# TOWN OF PLAINFIELD DESIGN REVIEW REPORT

DATE: ~~06-08-2023~~ 07-06-2023  
CASE NO.: [Not Docketed](#)  
PETITIONER: Evo Development  
REQUESTED ACTIONS: Architectural and Site Design Review for a proposed drive through restaurant  
LOCATION: 405 South Perry Road  
PARCEL SIZE: 1.3 acres+/-

The applicant is seeking Development Plan approval for a Cousins Subs drive-through restaurant. The proposed plan includes a 2,400 sq.ft. building, drive-through facilities, patio area, 25 off-street parking spaces, and other site improvements.

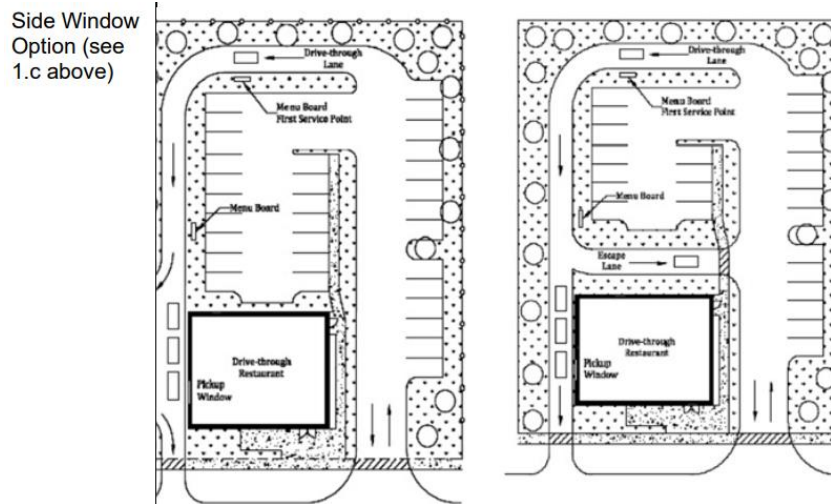
As noted above, the site is within an existing commercial subdivision which has a platted 30' Utility and Drainage Easement. The easement would prevent the building from being 20' from the west property line. The applicant's proposed layout shows the building being located approximately 100' from the Perry Rd.

right-of-way. The excessive distance appears to be necessitated by operational requirements of the drive-through which includes a waiting area located beyond the window.

The proposed drive through includes a pickup window on the side of the building and this design *may* be approved by the Plan Commission. Staff would note that the side window option was intended to offer flexibility in building design while still maintaining a building-forward site layout.
